NUREG-2245

Technical Review of the 2017 Edition of ASME Code, Section III, Division 5, “High Temperature Reactors”

Figure 3-4 Comparison of Average Values from SRS and Larson-Miller Analysis with the Seven Heats of NIMS 2.25Cr-1Mo Tubing Data, from ANL, 2021, Figure 2

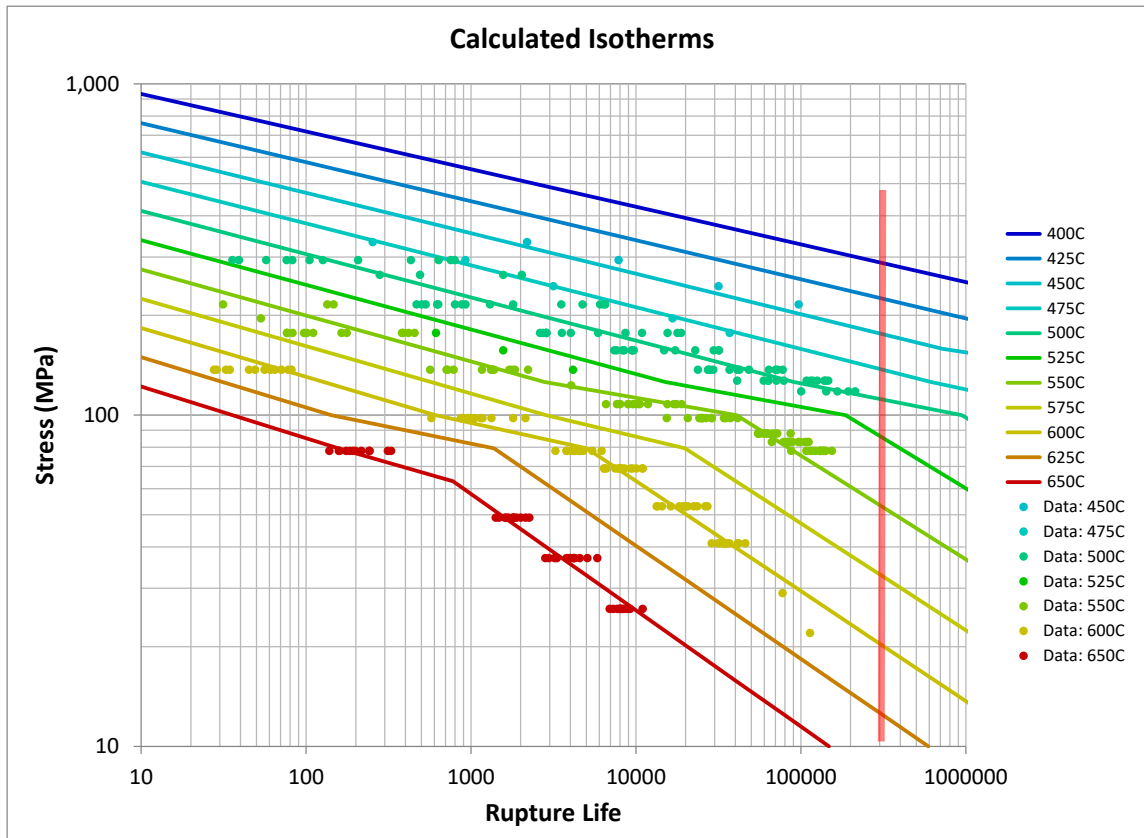
ANL, 2021 summarizes more recent work by Swindeman, which used a Stress Range Splitting (SRS) approach similar to that introduced by NIMS for 9Cr-1Mo-V steel to analyze seven heats of 2.25Cr-1Mo tubing materials from NIMS. Figure 3-4, reproduced from ANL, 2021, Figure 2, provides curves of applied stress versus average creep rupture life produced by the SRS analysis in combination with the Larson-Miller approach compared with the test data. The vertical red line in the figure shows the 300,000 hours mark. ANL, 2021 indicates that, from the standpoint of establishing a temperature bound for the use of the allowable stresses in Table HBB-I-14 of the 2017 Edition of the ASME Code, the data fit at 500 degrees C (932 degrees F) shows no excursion into the regime of rapid life degradation and a slight excursion at 525 degrees C (977 degrees F) starting at 200,000 hours. Therefore, for temperatures up to 500 degrees C, the staff is endorsing the Section III-5 values for times up to and including 300,000 hours based on the observation of no rapid creep life degradation at longer times as shown by Figure 3-4.

ORNL's analysis determined values for 2-1/4Cr-1Mo that are lower than the Section III-5 S_r values by more than 10 percent for some longer times and higher temperatures. Nonetheless, Figure 3-4 shows that stress rupture values for 2-1/4Cr-1Mo do not rapidly degrade at longer times for temperatures up to 500 degrees C. Therefore, the staff is endorsing the Section III-5 S_r values for all times for temperatures up to and including 500 degrees C (SI Units) and 950 degrees F¹⁰ (US Customary Units). Table 10 of ANL, 2021 shows the S_r values based on the SRS analysis (detailed in Section 3.7.6) and the Section III-5 values of S_r , along with the percent difference between the two (D_4) at 100,000 hours. The differences are positive up to 550 degrees C and the difference is -5% at 575 degrees C. Although the percent difference at 525 degrees C is positive at 100,000 hours, at this temperature the S_r values begin to decline sharply at times greater than 100,000 hours which is not the case at 500 degrees C. Based on the positive percent difference at 100,000 hours for temperatures up to 550 degrees, the staff is endorsing the Section III-5 S_r values at 525-550 degrees and 1000-1050 degrees F for times up to and including 100,000 hours. Above 550 degrees, Figure 3-4 shows more rapid degradation of the S_r values beginning at shorter times. Therefore, the staff is not endorsing the Section III-5 S_r values for temperatures of 575 degrees C and above (SI Units) and 1100 degrees F and above (US Customary Units). The limitations on the endorsement of the S_r values for 2-1/4Cr-1Mo are for the same times and temperatures as the limitations on the S_{mt} and S_t values for 2-1/4Cr-1Mo. These limitations are depicted graphically in Table 3-2.

Figure 3-5 Comparison of Measured Creep Rupture Data Against HBB Prediction for Type 304 SS with 16-8-2 Filler Material (ANL, 2021, Figure 7)

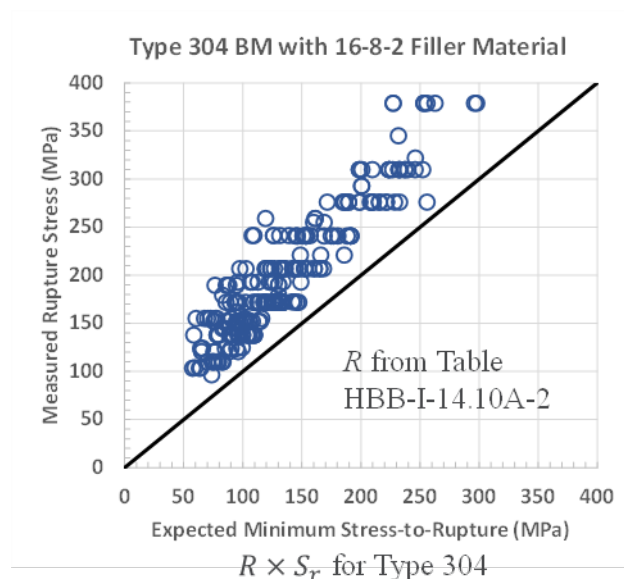
ANL, 2021 notes that the expected minimum stress-to-rupture (i.e., the minimum value of stress before weld rupture can occur) of the weld is an important design parameter in the weldment design procedures for primary load and creep fatigue. Its value is parameterized in terms of the stress rupture factor R and the tabulated base metal expected minimum stress-to-rupture S_r in HBB. Thus, the approach taken in the assessment of the R values is to check the available creep rupture data of welds and weldments against the expected minimum stress-to-rupture of the weld, determined as $R \times S_r$. Figure 3-5 shows a typical example from ANL, 2021 of actual creep rupture data plotted against $R \times S_r$ from Section III-5 for Type 304 SS base metal welded with 16-8-2 filler metal.

Figure 3-6 Values of S_y , S_u and S_m for SA-533 and SA-508 Materials Confirming that the S_m values for $T > 700$ Degrees F (371.1 Degrees C) are an Extension of those for $T < 700$ Degrees F (371.1 Degrees C) and are Conservative (NUMARK, 2020a)

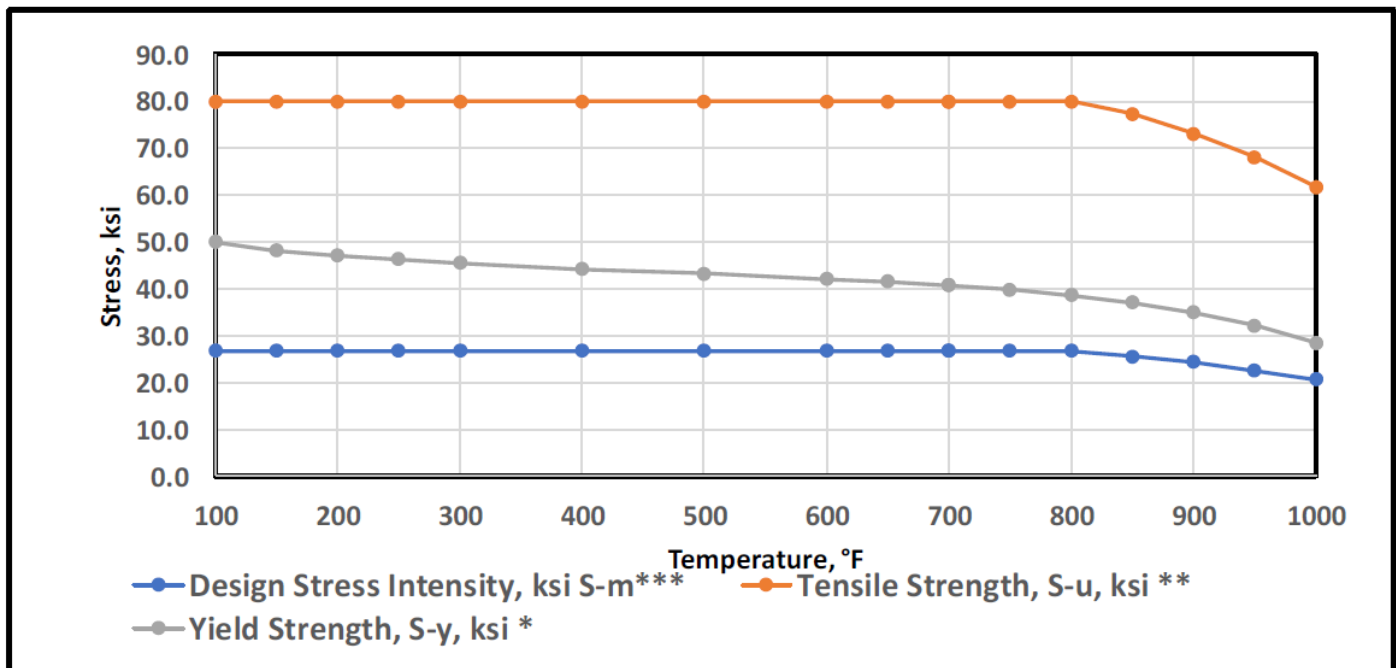
Figure 3-6 below shows the values of S_m , S_y and S_u for the two materials (which are identical) as seen in Table 3-4. As may be noted in Table 3-4, the Margin of Safety (S_u/S_m) for both materials for the entire range of temperatures is consistently 3.0, thereby confirming that the S_m values in Table HBB-II-3000-3 are both conservative and are an extension of those values in Section II, Part D, Subpart 1, as stated in this Appendix. The staff finds the evaluation of the material property values in NUMARK, 2020a to be acceptable because it used ASME Code material properties and methods consistent with those used to determine the allowable stresses in Section III-5.

Therefore, the staff finds HBB-II-2000 acceptable as written.

Figure 3-7 Example of a Comparison of Available Creep Data to the HBB-T ISSCs from Reference 2, for Type 304 SS at 700 Degrees C (1,292 Degrees F) (from Figure A-7 of NUMARK, 2020a)

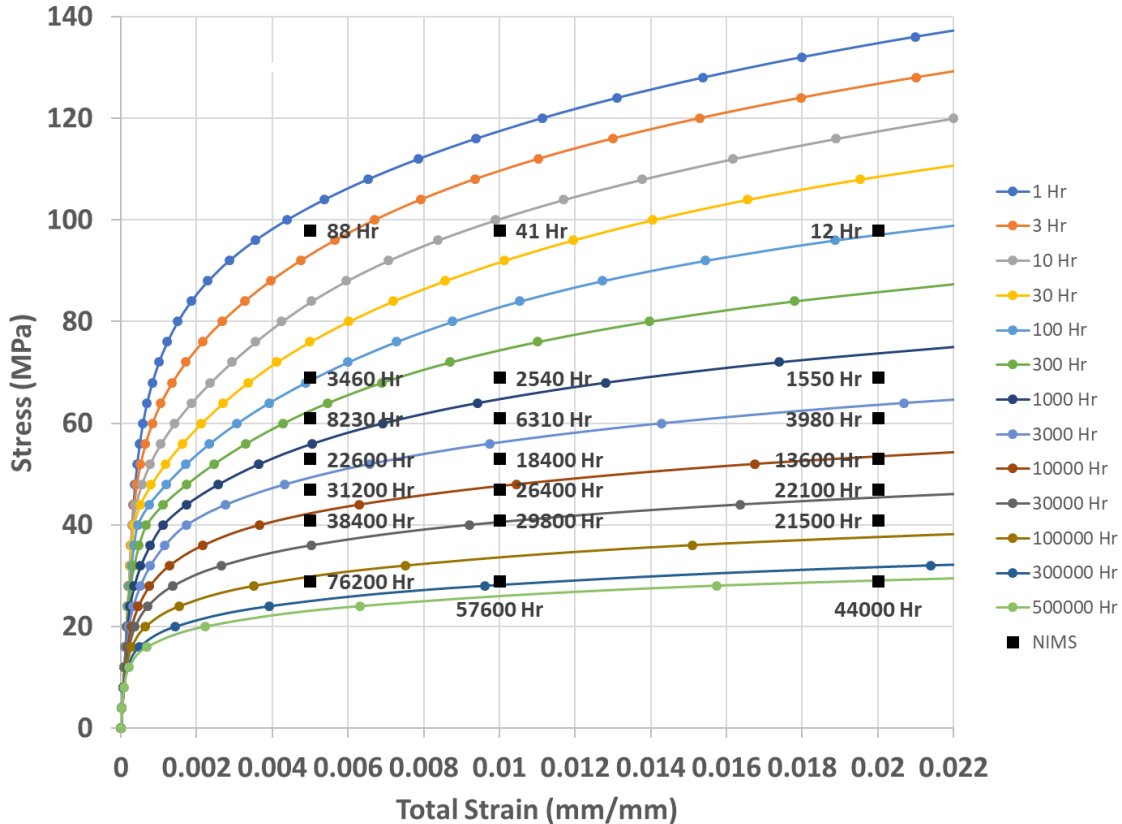
NUMARK, 2020a documents an independent review of the ISSCs in Figures HBB-T-1800-A-2 through HBB-T-1800-E-11. In the analysis documented in NUMARK, 2020a, available creep data for the five ASME Code III-5 materials were compared to the HBB-T ISSCs to verify the conservatism of the HBB-T ISSCs. The independent data were compared to the HBB-T ISSCs plotted using the underlying equations used to generate the HBB-T ISSCs. Figure 3-7 shows an example of a comparison for Type 304 SS at 700 degrees C (1,292 degrees F). In Figure 3-7, the black square points represent independent creep data from the Busshitsu-zairyō kenkyū kikō (NIMS) database. For example, the data point at 76,200 hours and a stress of 28 MPa and a strain of 0.005 lies approximately on the 100,000 hour HBB-T ISSC (brown line). This data point has a lower time for the same stress-strain combination from the HBB-T ISSC, which could imply the HBB-T ISSC is nonconservative. The black square at 29,800 hours at a stress of 40 MPa and strain of 0.01 lies exactly on the 30,000 hour HBB-T, which shows essentially identical results to the HBB-T ISSC.

When the independent data show a trend of significantly lower times for the same stress/strain combinations as the HBB-T ISSCs, NUMARK, 2020a suggests the HBB-T ISSCs may be nonconservative. This occurs for several materials, typically at higher temperatures and longer times, and is often attributed in NUMARK, 2020a to inaccuracies in the extrapolation of data to longer times when the HBB-T ISSCs were developed. NUMARK, 2020a further notes that, because creep data are highly variable with a large statistical scatter, the validation provided relies on some interpretation by the authors.

Figure 3-8 Comparison of the Stress Relaxation Profile Produced by the Algebraic Design-By-Elastic-Analysis ISSC Method to the Profile Produced by Integrating the Creep Model Underlying the HBB-T ISSCs through the Stress Relaxation Condition from Figure 19 of ANL, 2021

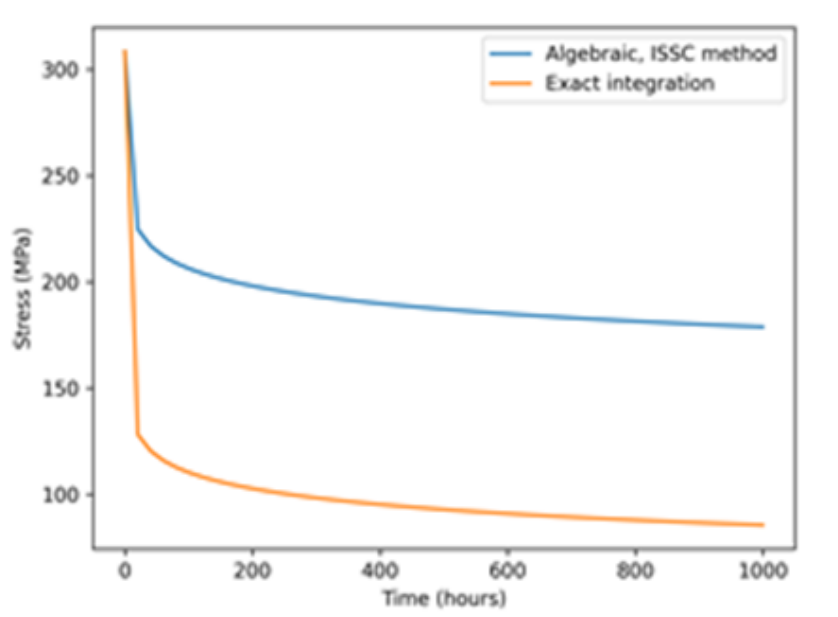
Second, the relaxation procedure using the ISSCs is inherently conservative. Figure 3-8 compares the relaxation profile calculated using the algebraic ISSC relaxation procedure in the design-by-elastic analysis rules (HBB-T-1433 Step 5(b)) to the relaxation profile given by integrating the actual creep model underlying the 2017 ISSCs through the stress relaxation condition. This example uses an initial stress of 310 MPa (0.5 strain according to the HBB-T hot tensile curves), at a temperature of 550 degrees C (1,022 degrees F), and a hold time of 1,000 hours. The algebraic method produces higher stresses and is, therefore, conservative compared to integrating the relaxation differential equation, which is more accurate.

Figure 3-9 Yield Stress Comparison Between Experimental Data, the ASME Code III-5-HBB Hot Tensile Curves, and the STP-PT-080 Hot Tensile Curves, from Figure 20 of ANL, 2021

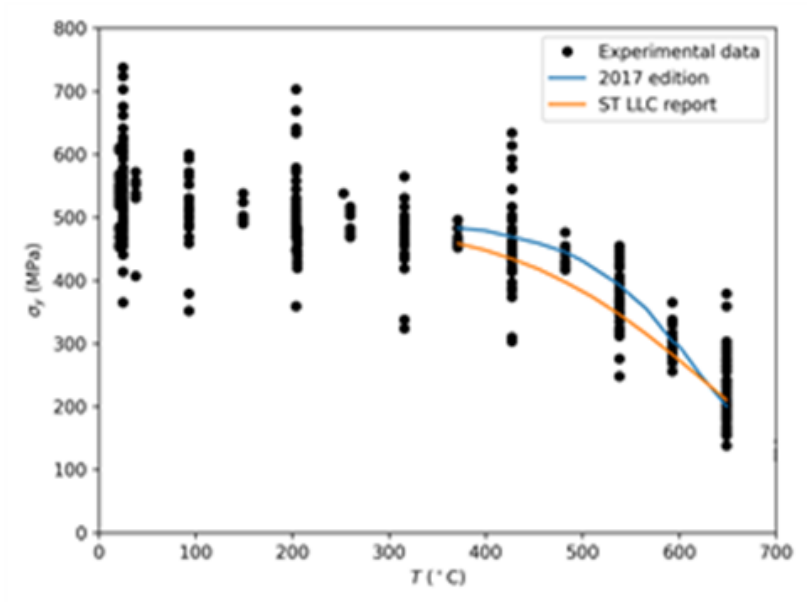
ANL, 2021 provides several examples of the large scatter in creep and deformation data, specifically for 9Cr-1Mo-V material. The first example, reproduced in Figure 3-9, is a plot of measured yield strength data versus the yield stress from the HBB-T ISSCs and the ISSCs from STP-PT-80, “Development of Average Isochronous Stress-Strain Curves and Equations and External Pressure Charts and Equations for 9Cr-1Mo-V Steel,” dated June 30, 2016 (Jawad et al., 2016). The plot demonstrates that the yield stress from both the HBB-T and the STP-PT-80 ISSCs are within the scatter of the actual data.

Figure 3-10 Comparison Between a Set of Experimental Creep Curves at 550 and 240 MPa Load and the Predicted Creep Curves Using the Models Underlying ASME Code III-5-HBB and STP-PT-080 ISSCs, from Figure 21 of ANL, 2021

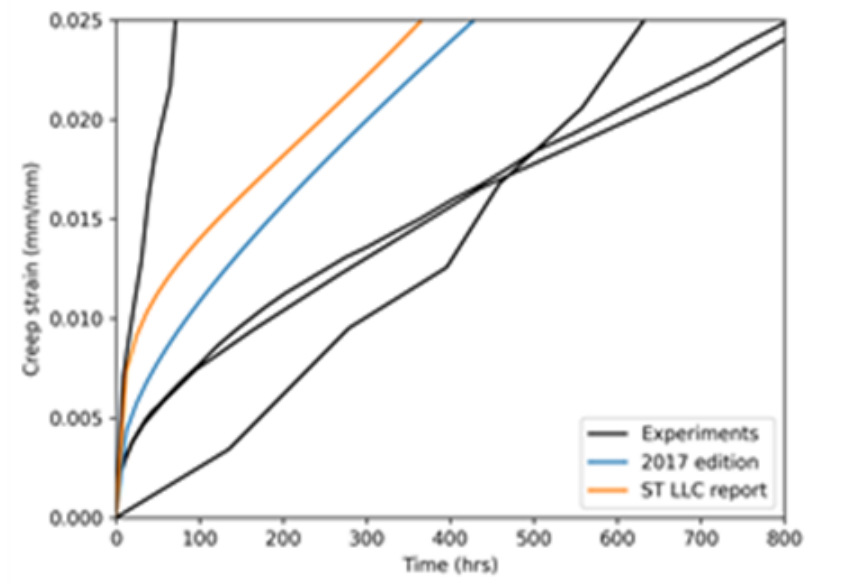
A second example, shown by Figure 3-10, is a graph of several actual creep curves for 9Cr-1Mo-V material, for the same stress and temperature, against the creep strains predicted by the creep models underlying the ASME Code III-5 and STP-PT-080 ISSCs. This plot illustrates the large scatter in creep curves for the same temperature and stress, and both HBB-T and STP-PT-080 ISSCs fall within the scatter.

Figure 3-11 Comparison of Grade 91 (9Cr-1Mo-V) Minimum Strain Rate Data from the United States and Japan with Predictions from Strain Equation for the HBB-T ISSCs, from Figure 22 of ANL, 2021

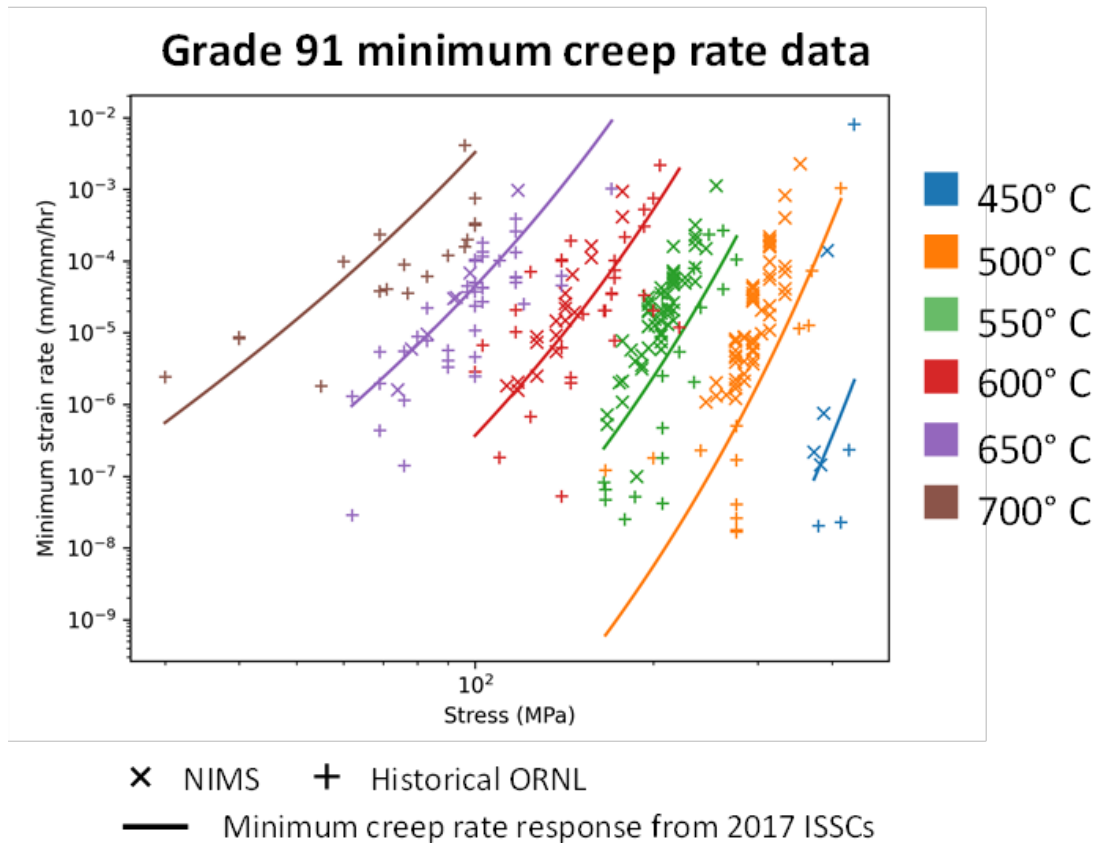
The third example in Figure 3-11 is a plot of creep strain rate versus stress for actual data from ORNL and the NIMS database, with curves of the creep rates predicted by HBB-T superimposed, which shows the HBB-T creep rates generally fall within the scatter of both sets of actual data.

The examples provided in ANL, 2021 show that measured creep rates and resulting creep strains can often vary by a factor of one to two orders of magnitude (10 to 100) for the same temperature and stress.
